Havant Thicket Reservoir

Statement of Community Involvement

Phase 5 – Control House

Document Reference: HTR-FUW-P5-CB-RP-W-1711

How will the brick and flint be combined?

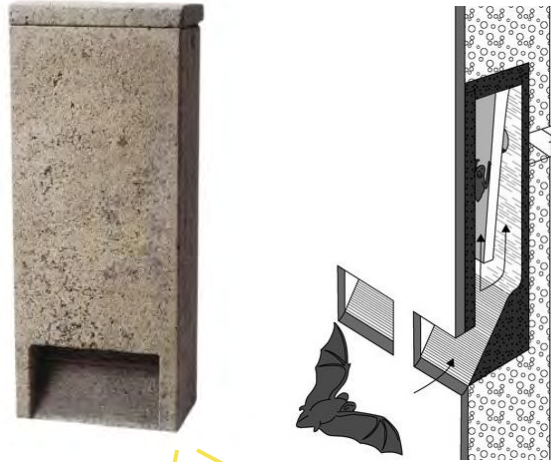
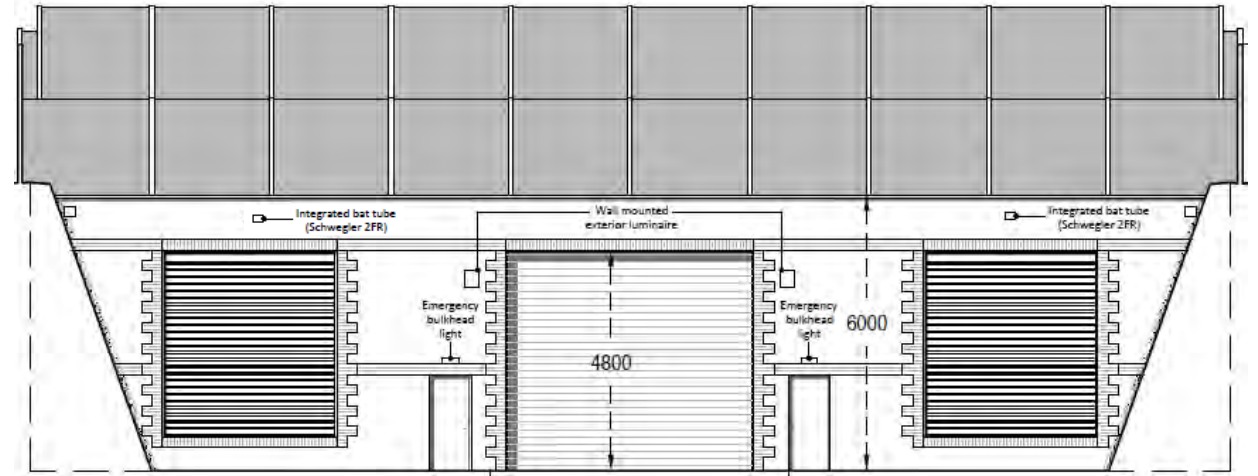
Photographs of local buildings kindly provided by stakeholders have been reviewed and **a combination of red brick and knapped flint** has been selected for the control building façade. This is considered to be in keeping with the surroundings of the reservoir including Staunton Country Park and Rowlands Castle.

The below drawings depict the flint and brick details presented on the building façade. These will be combined to deliver the final design as shown on the left.
